PIZZA TIME THEATRE

SPARKS, NEVADA

APPROVED
As Submitted
With Correction
Date: 5-27-92
By: [Signature]
Sparks Ridge Div.

PROPOSED FLOOR & ELECTRICAL PLAN

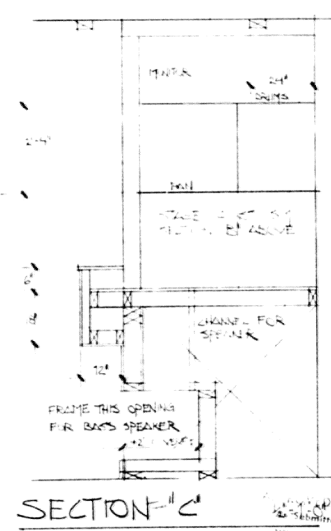
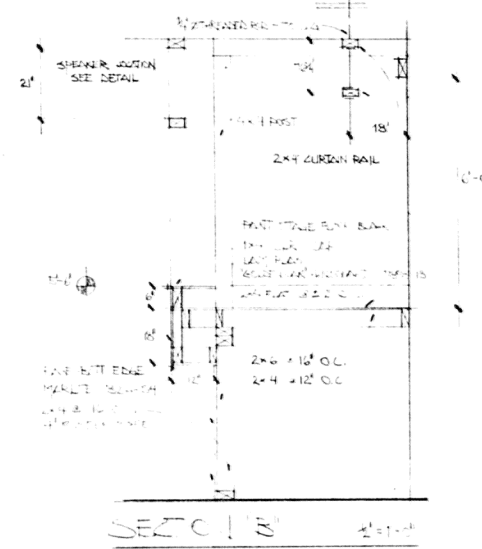
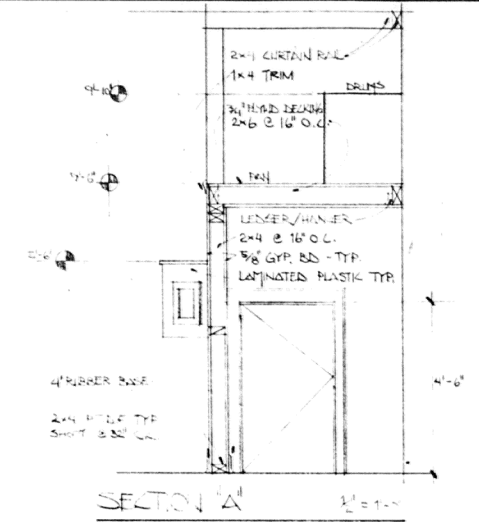
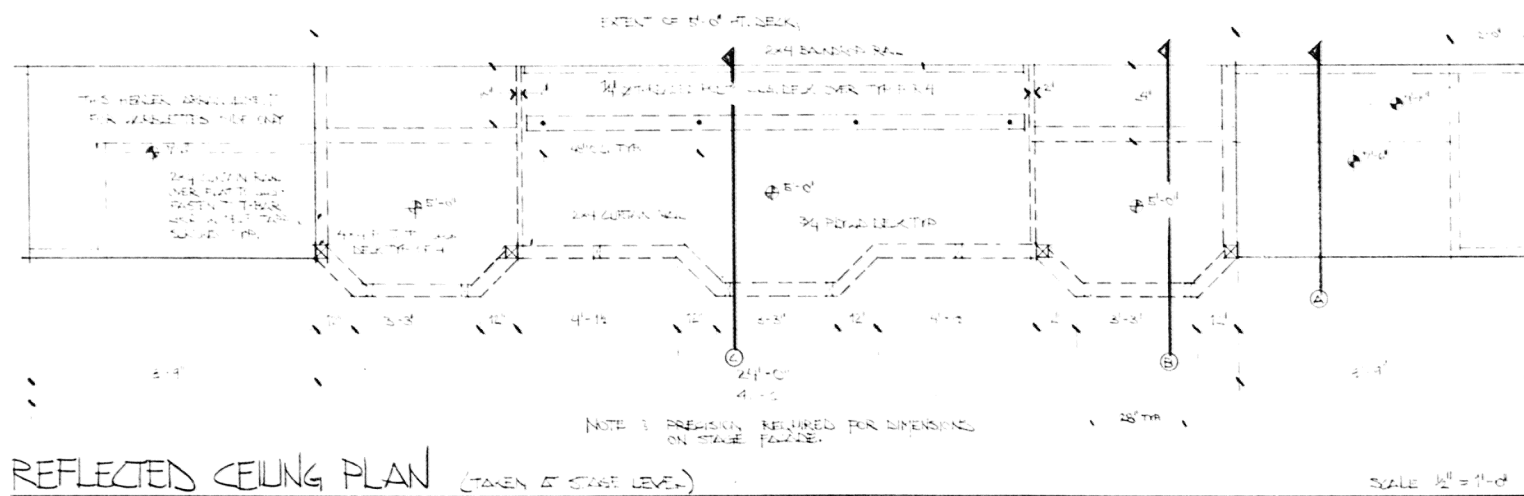
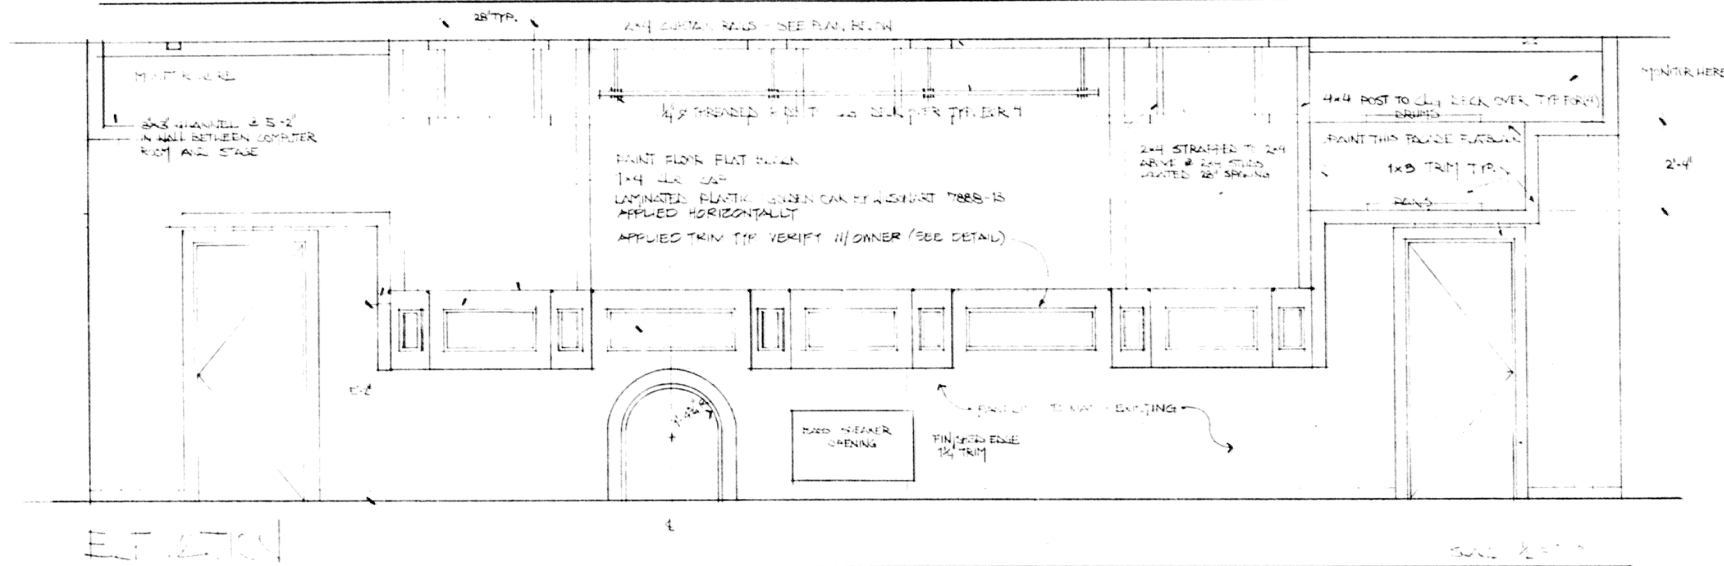
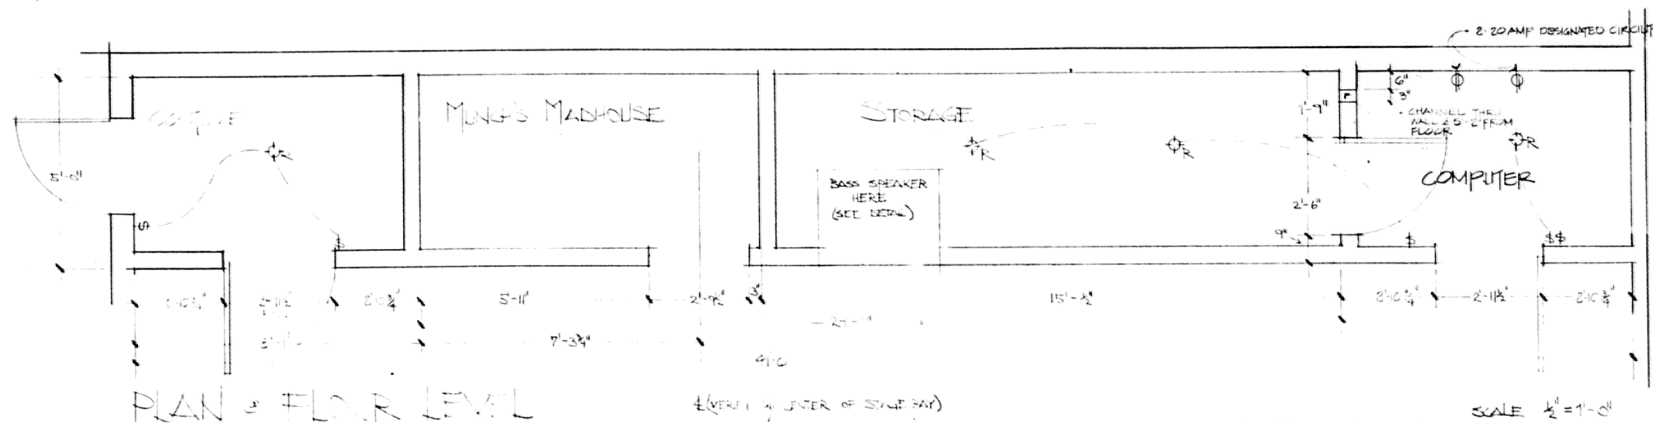
Fire Sprinkler -
must be alerted to a station.
Emergency lighting required
to show means of egress from
meeting at Bldg.

STAGE ELEVATION, PLAN, & SECTIONS

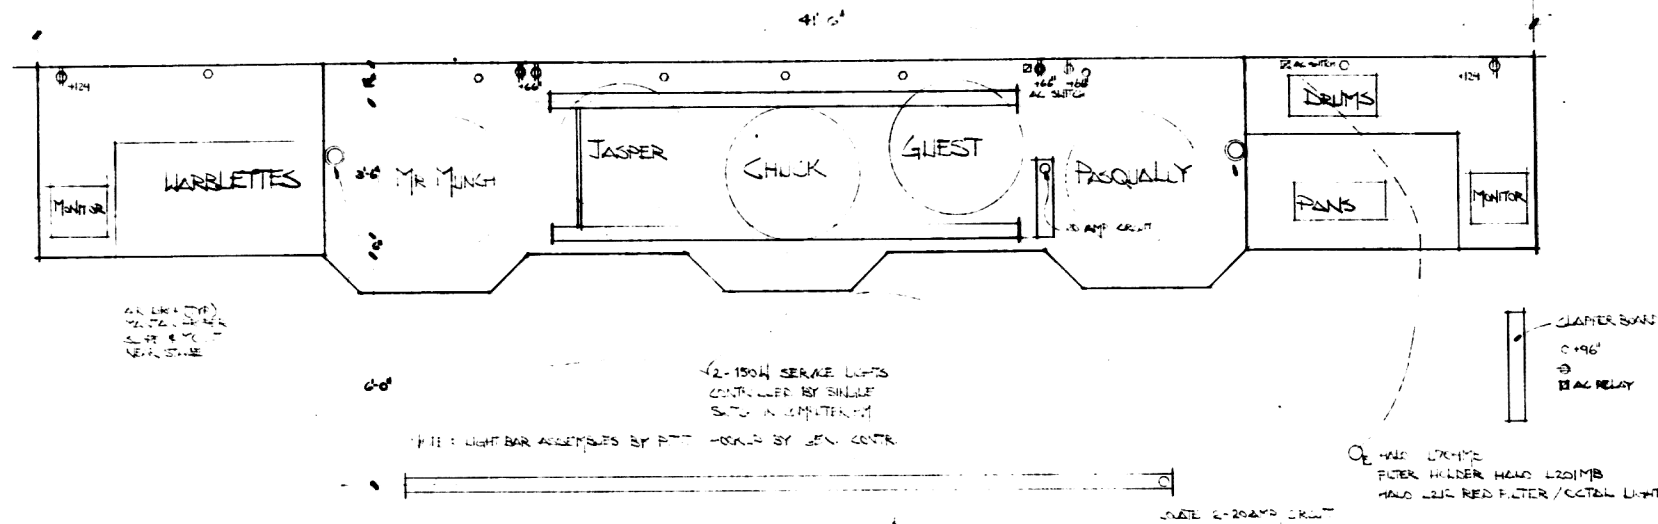
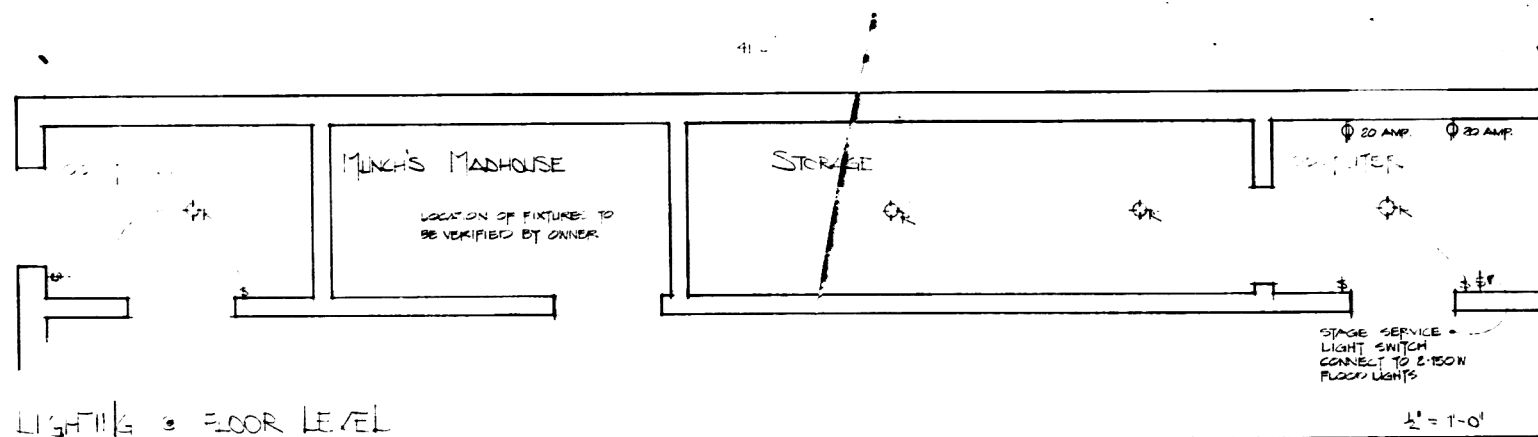
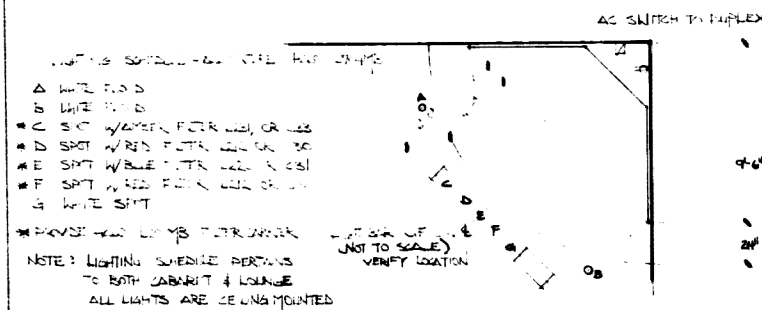
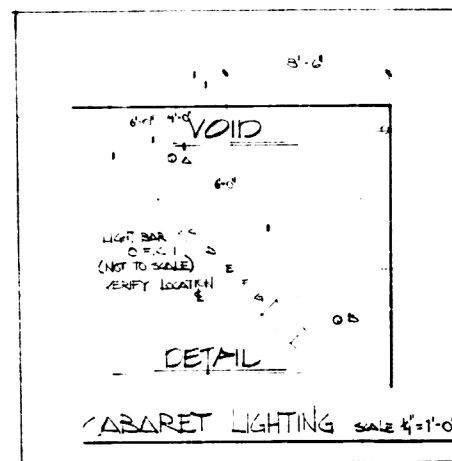
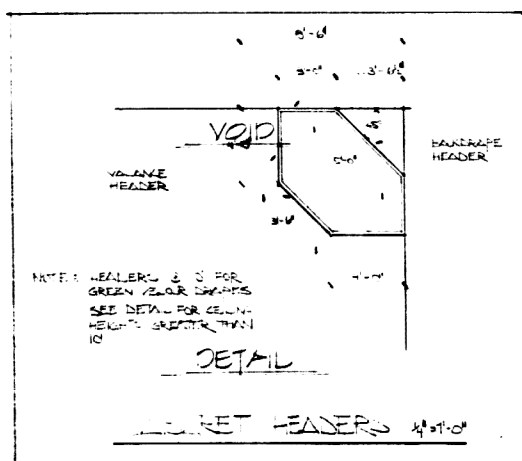
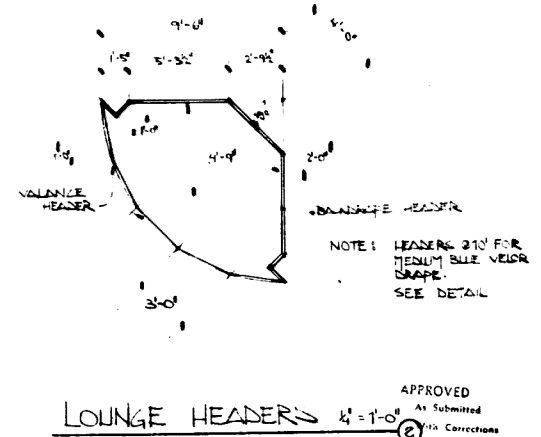
Sprinklers
Required under stage
and in dropped ceiling
area
